773-CHCGE281253

Rolleston West Plan Change

25 January 2021

Geotechnical Peer Review/RFI Response - Rolleston West Plan Change application

Borelog for well M36/8581

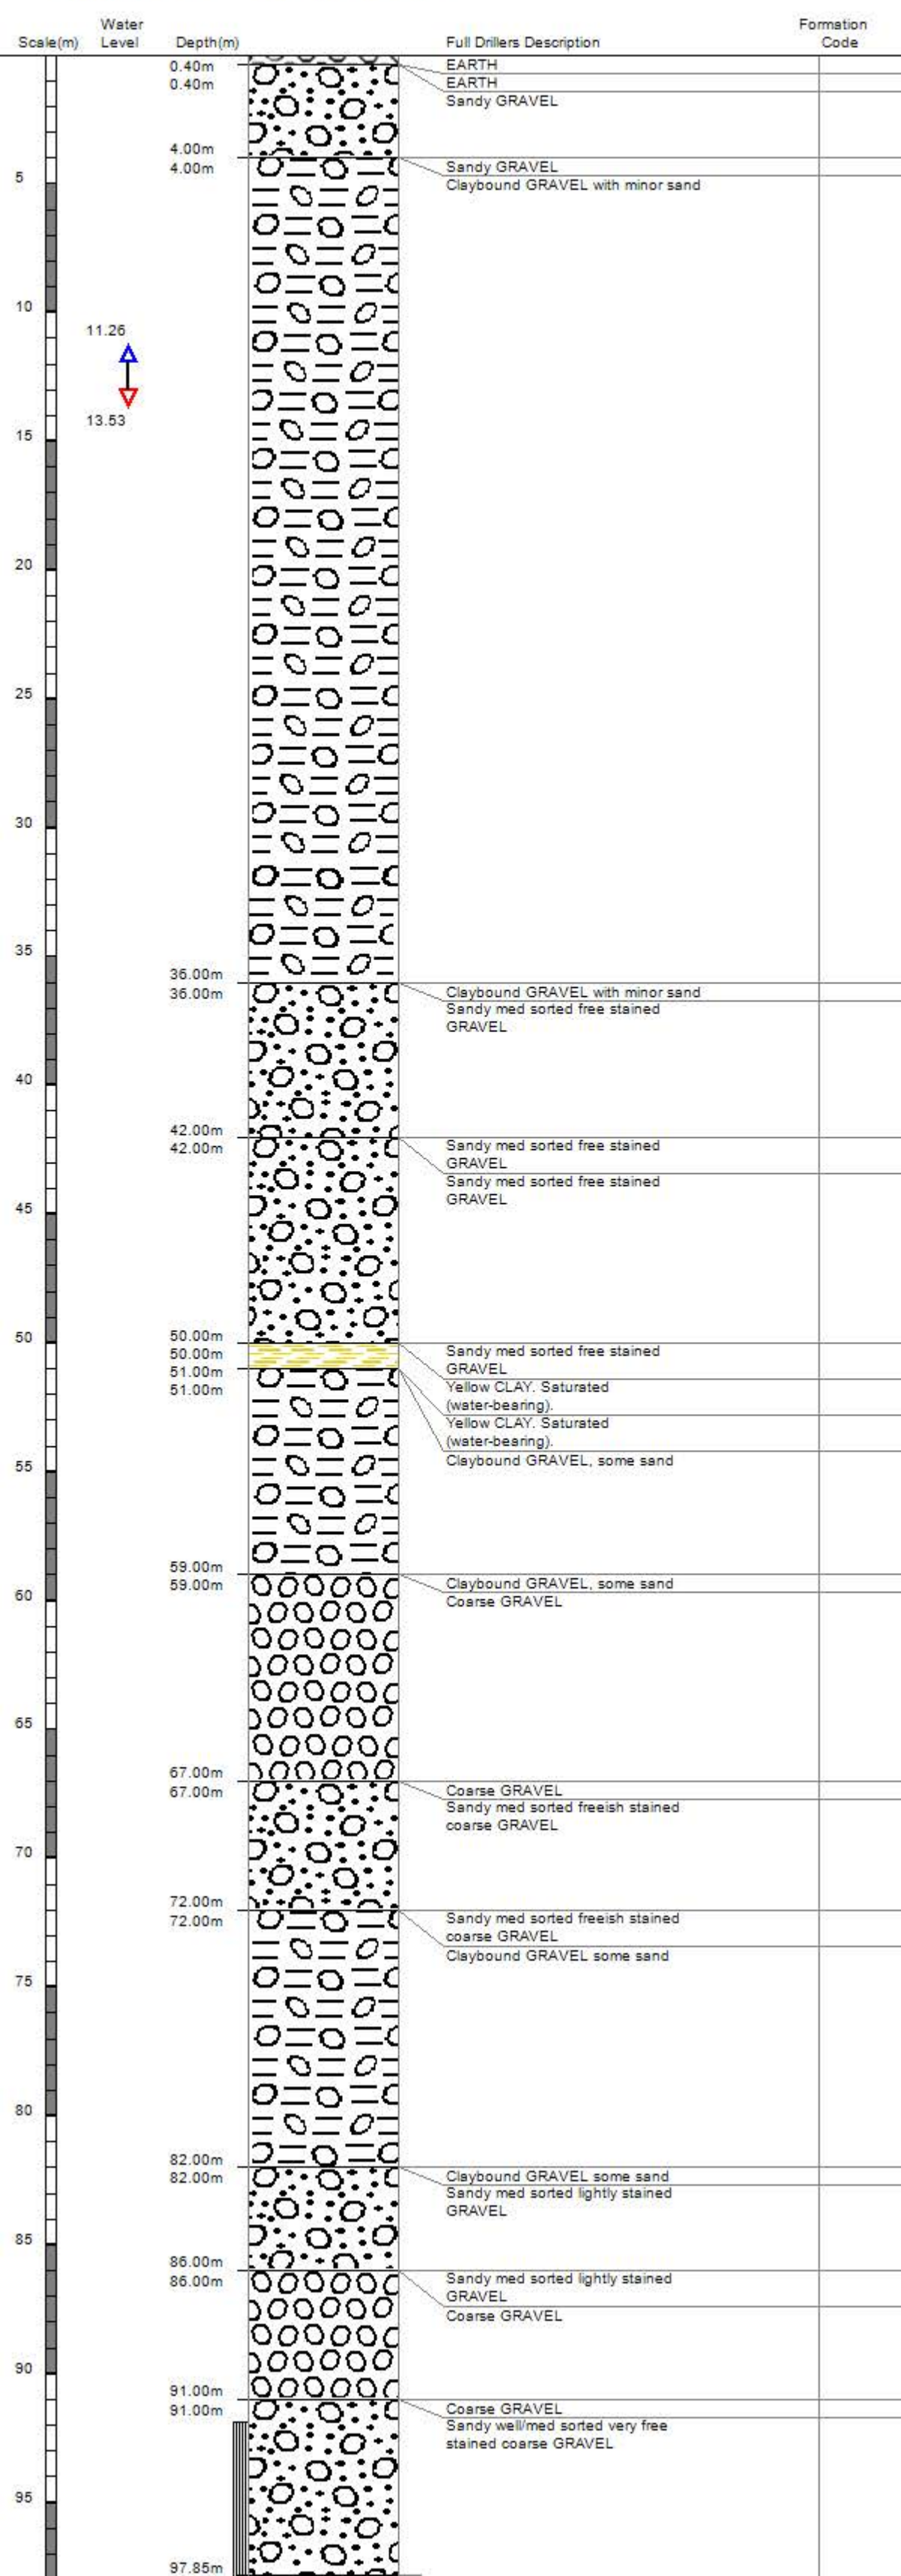
Coffey has reviewed the Environment Canterbury (ECan) well logs in the vicinity of the sites. All logs reviewed indicate a minimum of 50m of gravel deposits beneath both sites. Two examples of the well logs are attached for reference; M36/8063 is located adjacent to Burnham School Road (on the southern boundary of the Holmes Block) and M36/8581 is located in the northern corner of the Skellerup Block. We conclude from the ECan borehole logs and from the investigation test pits that the dense gravels are continuous under the subdivision sites.
